Request for Further Information and additional resource consents

Record Number/s: CRC184166, CRC200500, CRC201366, CRC201367, CRC201368, CRC203016
Applicant Name: Bathurst Coal Ltd
Activity Description: Various consents to undertake mining activities at the Canterbury Coal Mine

Figure 1: Gully seepage wetlands removed

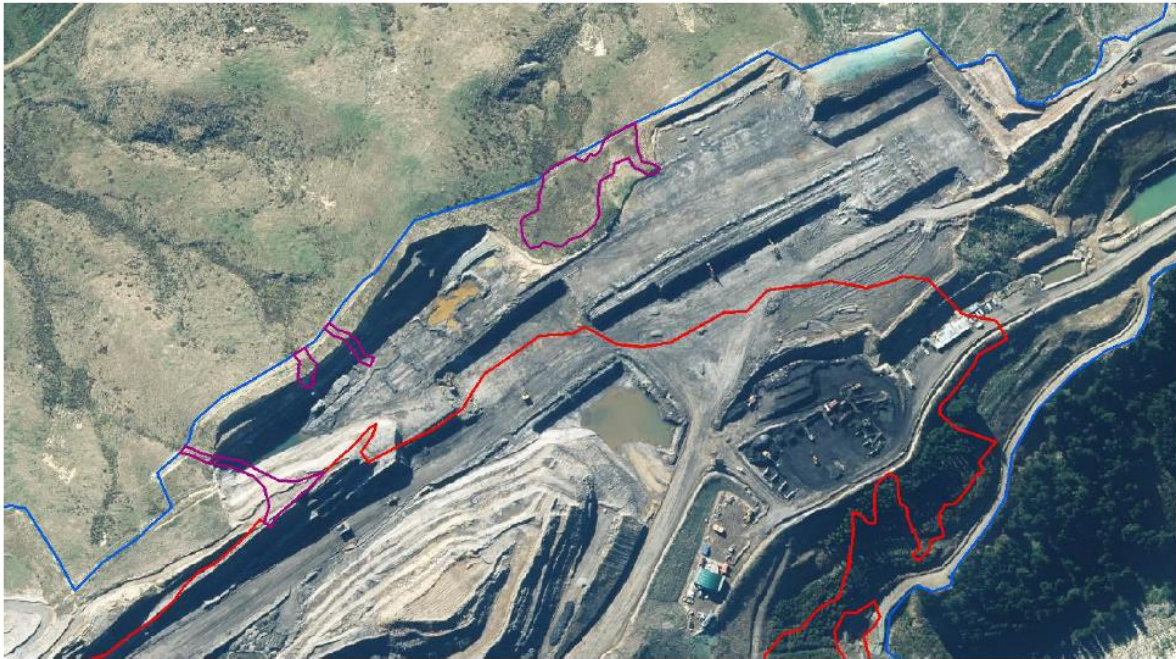
1. Dr Philip Grove has identified that approximately 1,700 square metres of seepage wetland habitat has been removed during mine expansion from 2013 and a further 3,800 square metres of seepage wetland impacted by the installation of a track within the MOA (See Attachment One). Whilst it cannot be conclusively proven these areas are seepage wetlands which meet the definition in the CLWRP, based on the aerial imagery, these areas appear extremely similar to those outside of the MOA and those that were identified in the North ELF. It is considered these are more than likely seepage wetlands and consent is necessary in order to authorise their removal.

I am concerned that, as discussed by Mr Davis in his report, recent aerial photographs and satellite images indicate that some wetland habitats and vegetation within the proposed MOA have already been disturbed/removed. I have looked at aerial imagery of the mine operating area in 2013 and 2019 which show its expansion over that period. Wetlands on hillslopes NW of the 2013 mine area have been impacted (additional to those impacted by construction of the North ELF). From this aerial imagery I estimate that about 1700 square metres of seepage wetland habitat have been removed by mine expansion. Another approximately 3800 square metres of seepage wetland, while still present, appear to have been impacted by recent track installation.

Figure 1 attached is a 2019 aerial photo showing the mine operating area at that time (blue outline), the mine operating area as it was in 2013 (red outline) and 'NW hillslope' seepage wetland areas (purple lines) that have been removed (west three) or otherwise impacted by mine activities (track and fence construction by the looks). Figure 1 indicates that the top end of several gully seepage wetlands have potentially already been affected. It is noted that this is just a desktop assessment based on the aerial imagery but is information the applicant was requested to provide and did not.

Is it proposed to provide any form of environmental compensation? If so, the following details are necessary:

- a) A description of the environmental compensation package and where it will be located.
- b) How the environmental compensation package will ensure there is an environmental net gain?
- c) How the environmental compensation will be protected and endure for perpetuity.
